TECHNICAL SERVICE BULLETIN

Number: TSB-FC-2016-001 SC6500 Recovery Tank Latch

Symptom: Recovery tank latch will not close.

Fig.1

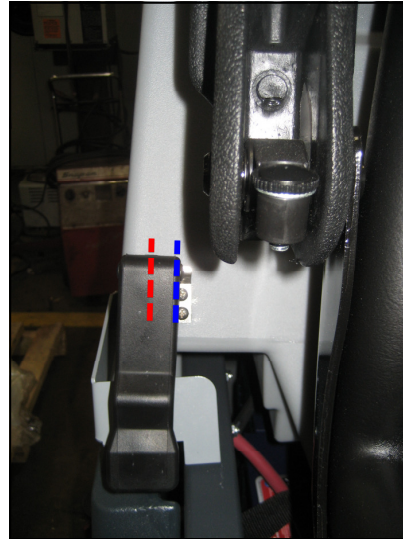
Recovery Tank latch and the clip it fastens to are out of alignment. (Fig.1 & 2)

Variation in the rotomolded tank along with some adjustability of the tank position.

Fig.3

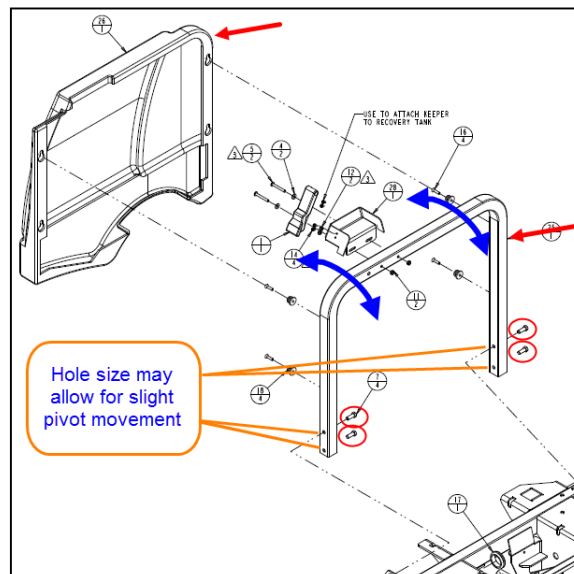
1. The square tube support bar that the side panel is attached can be push in or pulled out, as it will pivot some on the mounting bolts. Remove the rear side panel (Fig.3) by lifting it up and off the key hole slots, then push or pull the square tube support bar in or out (Fig.4,5). Loosen and retighten the mounting bolts if necessary.

Fig.6

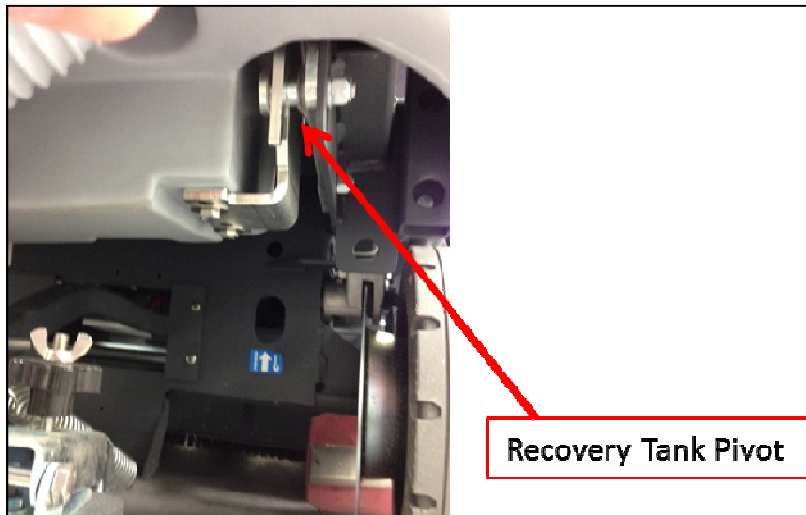
2. Additionally the recovery tank has some side to side movement available on the lower tank pivots - the tank can be pushed to the right or left. The recovery tank has pivots at the bottom of the tank and the tank can be pushed left or right within the limits of the pivots (Fig.6).

These two adjustment are typically enough to overcome the variation of the rotomolded tank.
